RESPONSE TO REQUEST FOR INFORMATION – DA2020/256 2-6 Pilgrim Avenue and 11-13 Albert Road, Strathfield

The following table includes a response to Strathfield Municipal Council's (Council) Request for Information, dated 31 March 2021 and 26 April 2021, the Design Review Panel's (DRP) Meeting Report and Recommendations dated 20 January 2021 and 19 May 2021, comments from Transport for NSW (TfNSW) dated 23 March 2020 and Record of Briefings at the Sydney Eastern City Planning Panel (the Planning Panel) held on 22 April 2021 and 10 June 2021. For completeness, the full text of each request is provided in the left-hand column, accompanied by the Proponent's corresponding response in the right-hand column. The Proponent's responses have been informed by input by the expert consultant team and, upon completion of the formal RFI response (to be submitted to Council post-Panel briefing) should be read in conjunction with the covering letter and accompanying technical reports and plans.

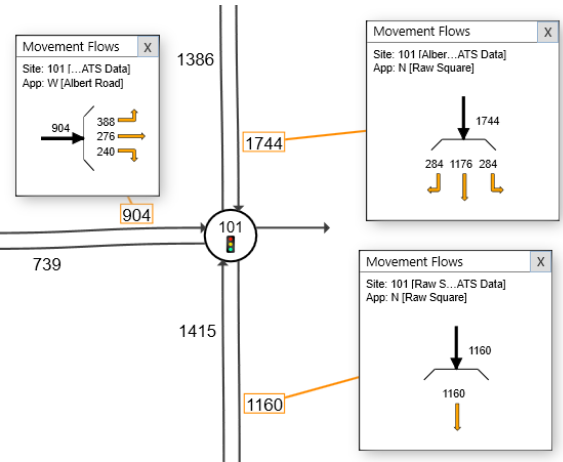
6. Built form and External facades		
14A	6.1 The scheme presents as a hard, relentlessly dense building with monolithic built form and architectural expression.	The new two tower scheme presents two more slender tower forms, with added articulation through the use of screens and angled louvres. As such, the scheme no longer presents a hard, relentlessly dense and monolithic built form, but has been logically broken up and articulated.
